PLANNING, ZONING, & BUILDING DEPARTMENT  
PZ&B Staff Combination Memorandum: Architectural Commission and Town Council

SUBJECT: ZON-24-0046 (ARC-24-0090) 2720 – 2730 S OCEAN BLVD

MEETING: MAY 14, 2025

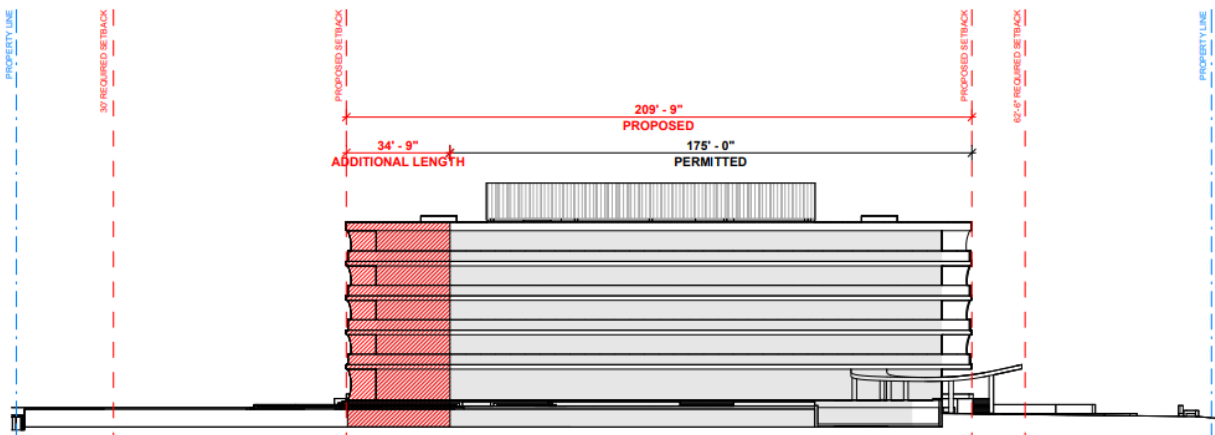
**Variance #1** requests to exceed the maximum lot coverage by 9% for new five-story building with 30% lot coverage in lieu of the 22% permitted for the west lakefront (Edgewater) parcel, inclusive of the subgrade garage and terraces. The proposed building and other covered area total 25,125 SF of lot coverage on the 81,461 SF site. This is roughly 7,204 SF over what is permitted.

The underground garage level counts towards the lot coverage, including when it is outside of the building envelope. In this proposed projecting balconies in the above ground levels align with the outline of the garage. The garage level measures approximately 110'-0" wide and spans 199'-9" deep into the 398'-0" long site to accommodate 38 parking spaces: 6 in private garages, 28 more

The design features two covered elements and the underground pedestrian tunnel that total approximately 2,054 SF that also count for lot coverage calculations. As stated above under the special exception review for five story buildings, the guidelines for five-stories does limit the lot coverage to not exceed 22 percent. It seems counter intuitive to make an allowance for height of stories provided it retains a lot coverage of a certain amount and then proceed to request a variance from that amount. Staff would recommend at minimum, removing the other 5,150 SF from the main residential structure to request a building that complies with the 22% lot coverage except for these abovementioned elements, or a lot coverage of 20,365 SF which is 25%. This will significantly lessen the overall footprint of the building, and/or reduce the extension of the projecting balconies along the upper levels. Or outright deny the variance request.

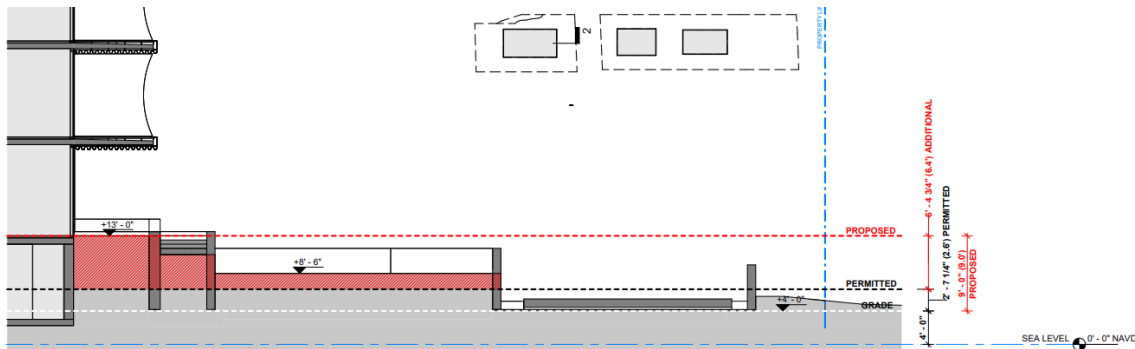
**Variance # 2** requests to exceed the maximum building length from 175'-0" to 209'-9" inclusive of the subgrade garage and terraces for the west lakefront (Edgewater) parcel. The applicant is seeking to permit an additional 35'-0" of building length, or a 20% increase. This regulation is in place in order to secure mass reduction breaks in the building that reduce the horizontal scale of the building into smaller more discrete sections. In staff's opinion, this standard regulates the amount of length of a building that controlling the overall structures in order to minimize a solid and continuous mass of building on any given site and their potential to infringe upon abutting properties light and air through the regulation preventing a continuous uninterrupted solid wall.

The west site is at the northernmost edge of the R-D(2) zoned land north of Lake Worth Bridge and contains no abutting property to the north. The site is approximately 398'-0" deep is relatively 'flat' with little elevation change from sidewalk to the west edge of the site, with the exception of the man-made seawall. The applicant is also seeking a lot coverage variance (variance #1) which would limit the footprint of the mass on the site. The building does comply with both front and rear setbacks, but does seek relief from both side setbacks (variances #4 and 5)—perhaps an indication that the mass of the building is not centrally located on the site and is larger than what should be expected—not only in length. The sole abutting property is the neighboring building to south which has a rather unique site plan, as it contains a serpentine building footprint that matches with its "S" shape five-story form.

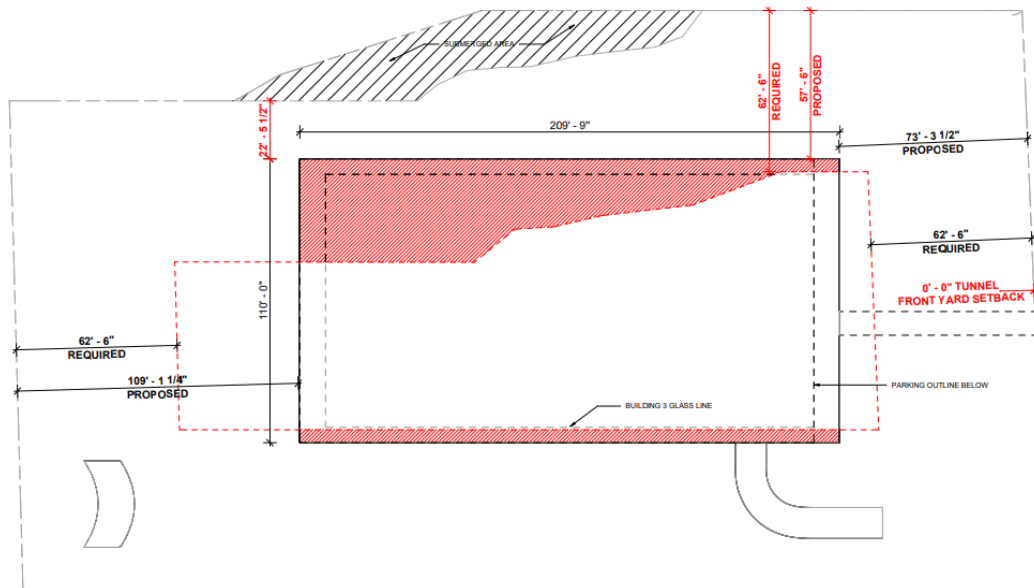
**Variance #3** is to exceed by 6.4' the maximum amount of fill in required yards to permit 9.0' of max fill in lieu of 2.60' permitted on the lakefront Edgewater parcel. Pursuant to Ord # 19- 2021, the code was modified to limit the maximum amount of fill that can be added to a site, specifically

within the required yards. Prior to this code amendment, a parcel was required to be filled up to 8" below the design elevation of the first floor. Now, a calculation determines that maximum by taking the values of the highest crown of road and subtracts that from the design floor elevation and then divides that number by 2. In this case, the crown of road is 4.8 NAVD and the finished floor elevation is 10.00 NAVD. Therefore, the maximum amount of fill ( $10.00 - 4.8 = 5.2 / 2 = 2.60'$ ).

The west site is relatively flat, as it generally maintains the same elevation datum from the crown of road (4.8') to the seawall. Current FEMA code was most recently amended with the Dec 20, 2024 adoption of the latest FIRM, and requires that the minimum floor elevation be set at 10' NAVD (BFE+1' freeboard). This creates a 5.2' height difference. The applicant is seeking to place the required parking under the existing building area in order to utilize this interstitial space between grade and design floor elevation. In doing so, the design would create a garage parking level that would be considered a story and not a basement, as it would not be below grade. In order to conceal the level underground, the applicant is seeking to bury the parking level by covering it with fill—exceeding what is permissible by code in order to conceal the parking and have it meet the definition of basement.

**The significance of this FILL variance cannot be overstated.** Simply put, without the granting of the fill variance, the project would contain an exposed parking level that would qualify it to be a six-story structure. The applicant has submitted a Hold Harmless agreement to the Town (approved by the Town Attorney and Planning Staff) to allow the project to move forward through the land use process. In short, without the granting of the fill variance, the proposed design cannot be approved as it would be inconsistent with the Comprehensive Plan and incompatible with the Town's Zoning Code. Without the approval of the fill variance, the project CANNOT move forward.

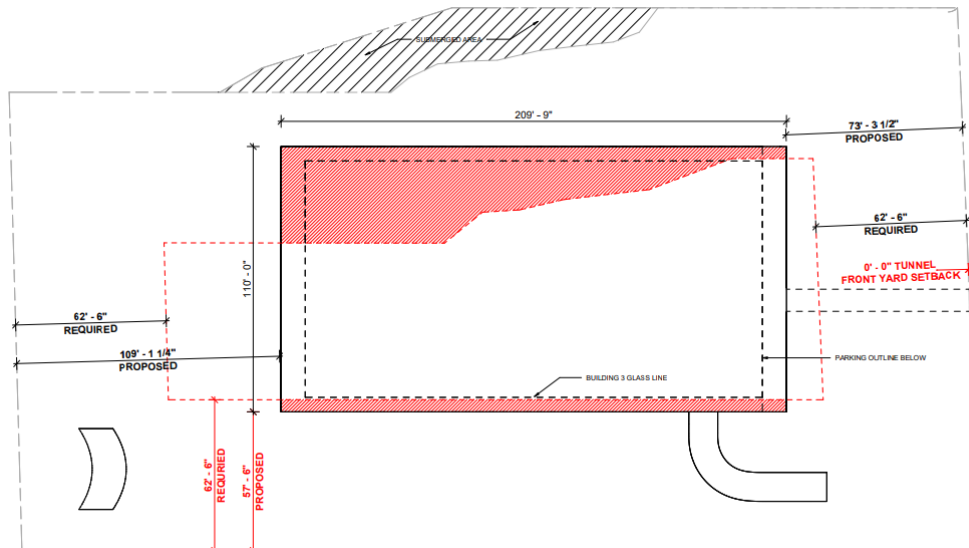
**Variance #4 and Variance #5** are variance requests to reduce both side yards at the lakefront Edgewater site. The request to reduce the required minimum **north** side yard setback to 22'-5 1/2" in lieu of 62'-6" required is based on the unique-to-the-site scenario where there is no abutting property to the north, the site has a natural inlet of Lake Worth Lagoon.

Additionally, the subject property's unique jagged edge elicits a setback challenge, as the required 62'-6" tapers inward of the site as it follows the irregular coast line/property line of the subject property. That said, the proposal does not comport with the requirement at the eastern portion of the site where the parcel is rectilinear in shape; the variance setback request varies from 27'-6" to 22'-5" as the building moves westerly. The primary goal of zoning setbacks is to ensure adequate spacing between structures, promote safety, enhance privacy, and improve the aesthetic quality of neighborhoods by regulating building placement and mass/density upon neighboring buildings. Considering there is no impact upon a neighboring property, it would make sense that the setback requirement to the north be reduced. The closest abutting property to the north, a seven-story residential building @ 2560 S Ocean Boulevard, is located over 1,500' away to the north across water and nature preserves. It should be noted that the existing north setback of the Edgewater building is 11'-3" to the north property line. As such, perhaps the applicant could shift the building even further to the north if the Council finds merit in that scenario. There are certain elements that are within this reduced setback in the proposal that have been designed as private gardens and pools for the first level residences.

The other variance to reduce the required minimum south side yard setback to 57'-6" in lieu of 62'-6" required seems contrary to the benefit of shifting the property within the required north yard. While staff finds some merit in the reduction of the north side setback due to a lack of neighboring property that would be directly impacted, the request is for to provide only 36% of the requirement. However, if the design decision was to alleviate the mass and location of the building from the neighboring the property to the south, in order to preserve view corridors and reduce potential shade impacts, then the south side variance (variance #5) should be withdrawn and the above-grade building shifted 5'-0" to comply with the regulation, or, at minimum, be denied.

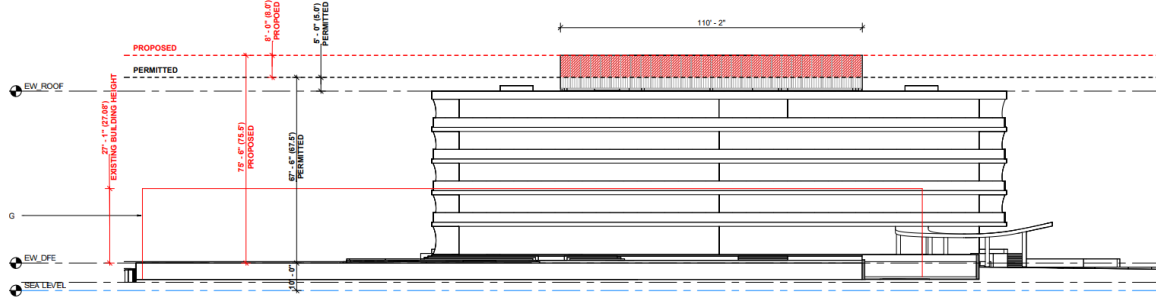
**Variance #9** is a request to exceed the overall building height (roof height) by 13’-0” for a height of 75.5’ in lieu of the 62.5’ of building height permitted, due to elevated finished floor elevation and the height of the rooftop mechanical equipment and related screening (on the lakefront

Edgewater site). The finished floor elevation of the site is proposed at +13' NAVD where +9' NAVD is the minimum required. This 4' additional feet in height exacerbates the need for this rooftop variance, as if the site was designed at the minimum finished floor elevation requirement and with the same proposed floor to floor ceiling height, the overall request would be reduced to a 9 ft variance instead of 13 ft. This building height variance is for mechanical equipment screening only.

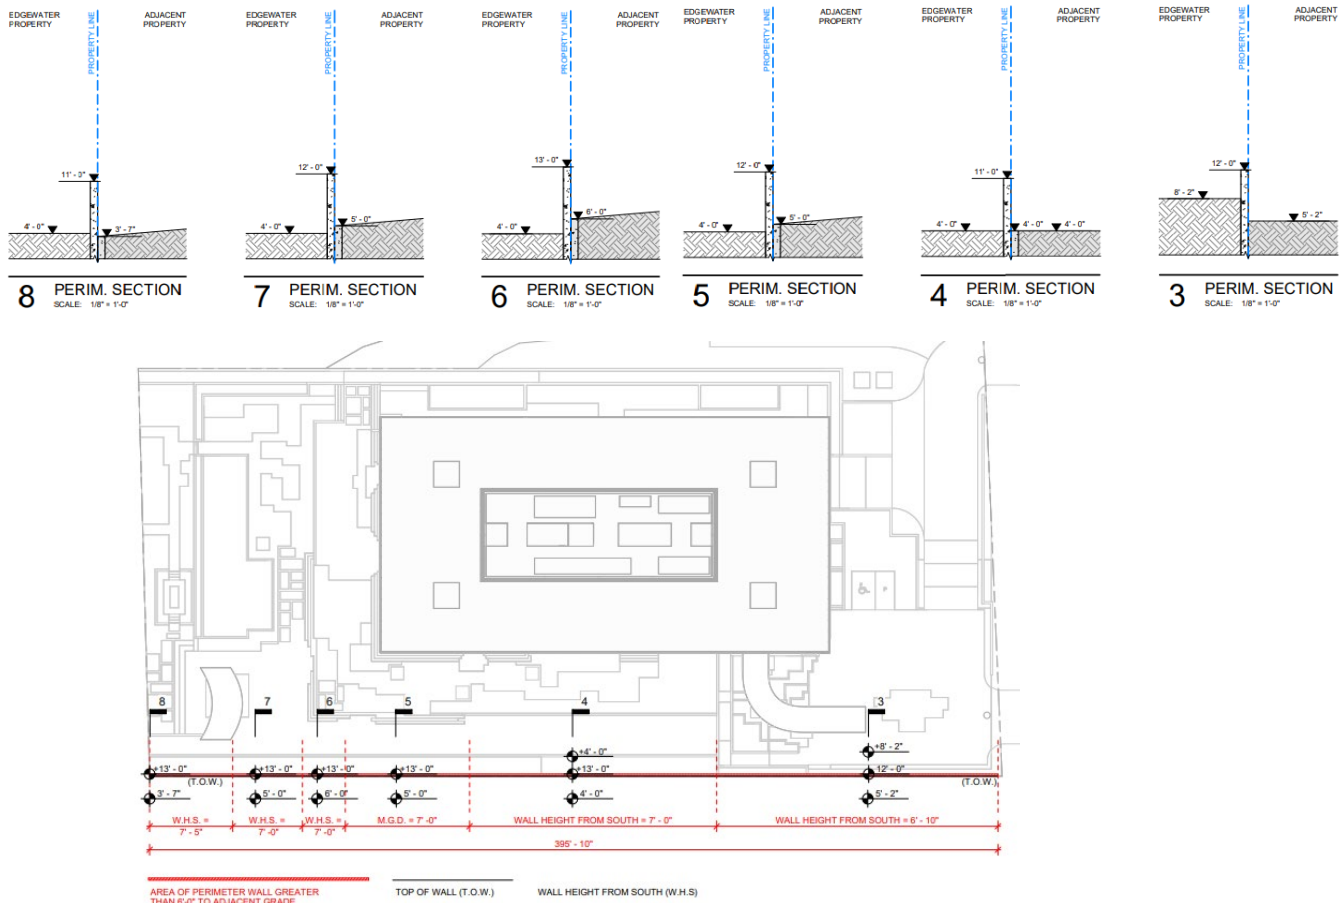
**Variance #10** is a variance to allow perimeter walls to exceed by 1'-0" for 6'-10" in front yard and 7'-6" in side yards. Walls located on these property lines must be measured from adjacent grade. Since the applicant is seeking to significantly raise the overall height of the parcel through adding fill to the sides and front and rear yards, the code maximum height does not work. The proposed variance request falls along the south property line and is shown below.

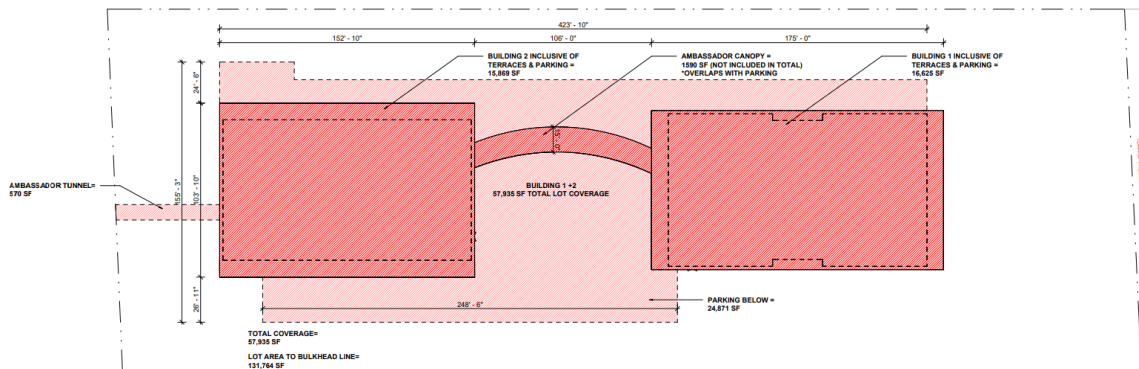
**Variance #11** to exceed the maximum lot coverage by 22% for new five-story building with 44% in lieu of the 22% permitted, for the east oceanfront (Ambassador) parcel, inclusive of the subgrade garage and terraces. The underground garage level counts towards the lot coverage, including when it is outside of the building envelope. The garage level measures approximately 155'-0" wide and spans 423'-0" deep into the 709'-0" long site to accommodate 87 parking spaces: 50 in private garages, and 37 visitor parking spaces for the 24 residential units. The slab elevation is set at 4'-6" NAVD, slightly below the 4'-10" NAVD highest point of South Ocean Boulevard. Below is the diagram showing in lighter pink the lot coverage inclusive of the parking level. The total coverage of the parking level and aboveground elements contains 57,935 SF, or 44% lot coverage on the 131,764 SF parcel. What is important to note that the portion of structure above grade (i.e. the two towers) is also above the lot coverage at 25.8% with 34,086 SF of area that includes expansive balconies along each of the upper levels and the connector canopy element at the ground floor.

Unlike the west site along the lakefront, the extent of the parking level considerably exceeds the outline of the footprint of the buildings above. Although the parking level is not visible from the right of way or from the air, the code requires that all areas of the buildings count towards the lot coverage. In fact, it requires that the portion of the basement outside the walls of the main building be counted towards the required setbacks and lot coverage. As stated above under the special exception review for five story buildings, the guidelines for five-stories does limit the lot coverage to not exceed 22 percent. The request herein contradicts that design guideline. If the Council finds merit in the argument that underground parking should not be counted towards the overall lot coverage, then staff would strongly recommend that, at a minimum, the above-ground structures should be reduced to comply with the 22% maximum lot coverage.

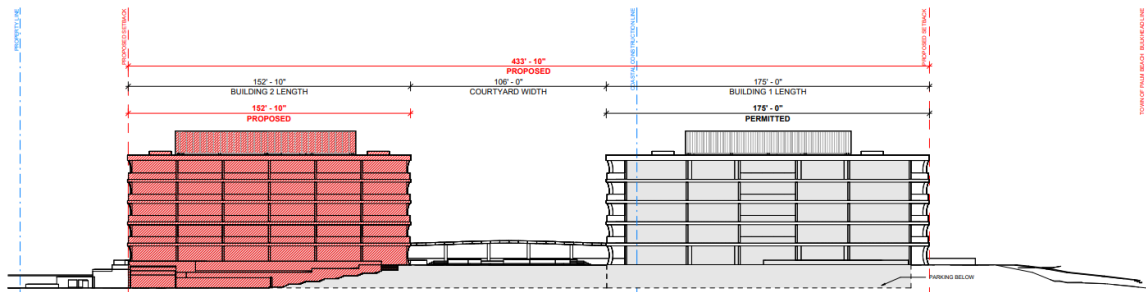
**Variance #12** requests to exceed the maximum building length from 175'-0" to 433'-10" inclusive of the subgrade garage and terraces for the east oceanfront (Ambassador) parcel. The Code requires that the maximum dimension of any structure or group of attached structures not exceed 150'-0"; the regulation does not cite aboveground structures, or rather does not exempt basements or subbasements from this rule. Therefore the subterranean parking level of the building(s) does count towards the overall building length. In staff's opinion, this regulation should only pertain to aboveground structures in order to minimize a solid and continuous mass of building on any given site and their potential to infringe upon abutting properties light and air, but the code currently does not distinguish such. It is important to note, that the portion of structure above the adjusted elevation, i.e. aboveground and actually visible to the public, does not exceed 175'-0" in length.

The east site is approximately 709'-0" deep and does contain abutting properties to the north and the south. The site rises dramatically from the edge of the road to the dune as one traverses the site east to west. When viewed above ground, the building is divided into two portions, or towers—building 1 and 2. Building 1 is furthest east and measures 175'-0" in length while building 2 is closest to South Ocean Boulevard and is 153'-0" long. Both "buildings" are separated by a 106'-0" wide courtyard. In this regard, with the exception of the connection of the subterranean parking level which spans 434'-0" in length, concealed predominantly in the dune, the design complies with the requirement. However, the variance request is for a 248% increase over what is permissible. This specificity should be addressed in reviewing the building length requirements as it pertains to substantially underground structures.

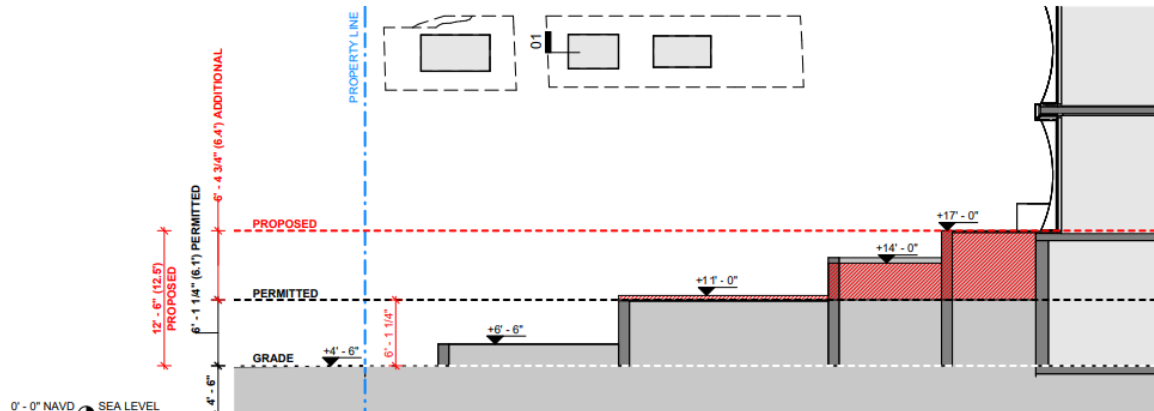
**Variance #13** is a variance to exceed by 6.4' the maximum amount of fill in required yards to permit 12.5' of max fill in lieu of 6.1' permitted on the oceanfront Ambassador site. With a finished floor level of 17' NAVD and a Crown of Road at 4.8' NAVD, the maximum amount of fill is half of the difference of these points, or 6.1' of fill.

The east site rises dramatically from the crown of road (4.8') to the dune of the ocean. Current FEMA code was most recently amended with the Dec 20, 2024 adoption of the FIRM maps, and requires that the minimum floor elevation be set at 10' NAVD (BFE+1' freeboard) for that portion of the building east of the CCCL (Coastal Construction Control Line) and 15.9' for that portion of the building west of this regulatory line. The applicant is placing both towers of the building at 15.9' which creates 11.1' height difference. The applicant is seeking to place the required parking under the existing footprint of the building area in order to efficiently utilize this interstitial space between grade and design floor elevation. This is done rather easily with the rising elevation of the site to the dune. However, in the front yard due to the dramatic difference, the applicant is seeking to exceed the maximum amount of fill to conceal the front wall of the parking level. Without this fill, the design would create a garage parking level that would be considered a story and not a basement, as it would not be below grade. Without the approval of the fill variance, the project CANNOT move forward.

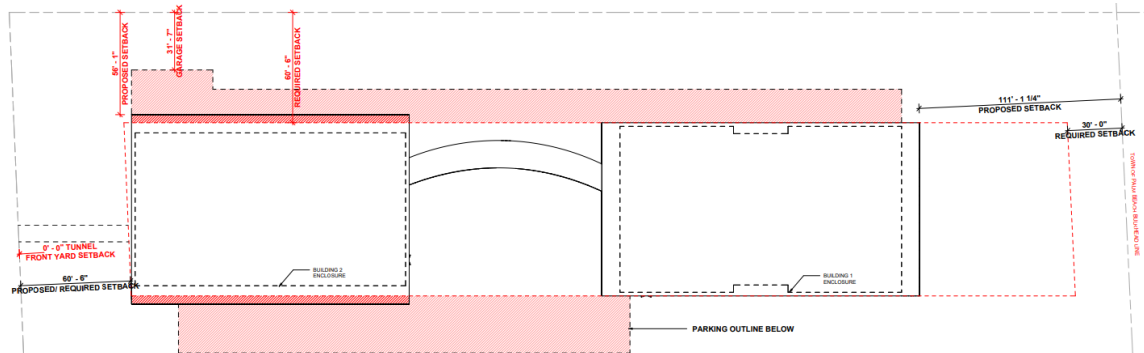
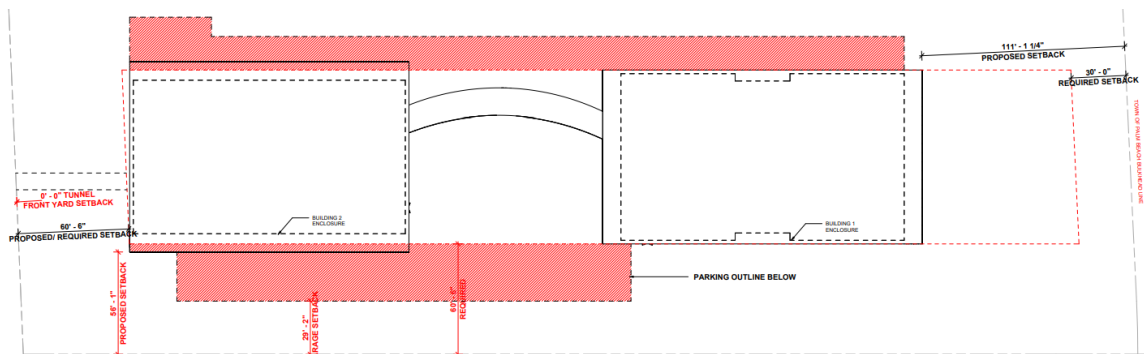
**Variance #14 and Variance #15** are variance requests to reduce both side yard setbacks on the oceanfront Ambassador site. The first request to reduce the required minimum north side yard setback to 31'-7" at its closest underground point although most of it is setback at 42'-2" in lieu of 62'-6" required. This distance is measured to the furthestmost northern edge of the underground garage level. However, it must be noted that the above grade structure (building 2) also does not comply—with a portion of the projecting balconies at all levels have a setback of 56'-1". The neighboring building to the north—"Beach Point 2660 S Ocean Blvd"—contains three nonconforming seven-story buildings, southernmost building has a setback of 68.3' to its property line.

The other side setback variance to reduce the required minimum south side yard setback to 29'-2" in lieu of 62'-6". This distance is measured to the edge of the underground garage. However, it must be noted that the above grade structure (building 2) also does not comply—with a portion of the projecting balconies at all levels have a setback of 56'-1".

Staff does find worth in the idea of having separate setback requirement for underground facilities (basements, subbasements, or below grade parking) versus the above ground, but currently the code does not distinguish between above and below grade structures. The applicant maintains that in both directions the proposed setbacks are improvements to the existing south setback of 29'-9" for the eight-story building. However, the existing north side setback is currently over 77'-0". In the recent 2024 Zoning and Land Use South End Survey performed by the Citizens Association of Palm Beach, 97.1% of the respondents indicated that side yard setbacks should not be reduced beyond what exists today.

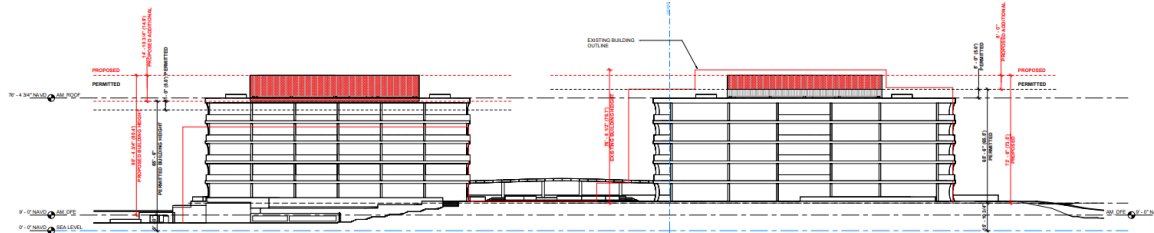
**Variance #19** is to exceed the overall building height (roof height) by 22.25 ft for a total of 89.75 ft in lieu of the 67.5 ft maximum building height permitted, due to the height of the rooftop mechanical equipment and related screening. The applicant maintains that the existing eight-story building has a nonconforming building height of 93'-0" and that the request is due to the mechanical screening only. The screening mechanism is to ensure that the new rooftop projections will be visually hidden from view. And has been designed to complement the building while working with staff to minimize its visibility.

**Variance #20** a variance to exceed the maximum overall building height of building #2 by 7 ft, for an overall building height of 67.5 ft in lieu of the 60.5' as measured from 9' NAVD point of measurement for the portion of the building located east of the CCCL. The applicant has designed the buildings under the assumption that that point of measurement of 15.9' for buildings east of the CCCL becomes the de facto measurement for the entirety of the buildings, since both independent towers area connected vis a vis the underground parking level. It is the interpretation of the department that the building contains two points of measurement—east of and west of the CCCL.
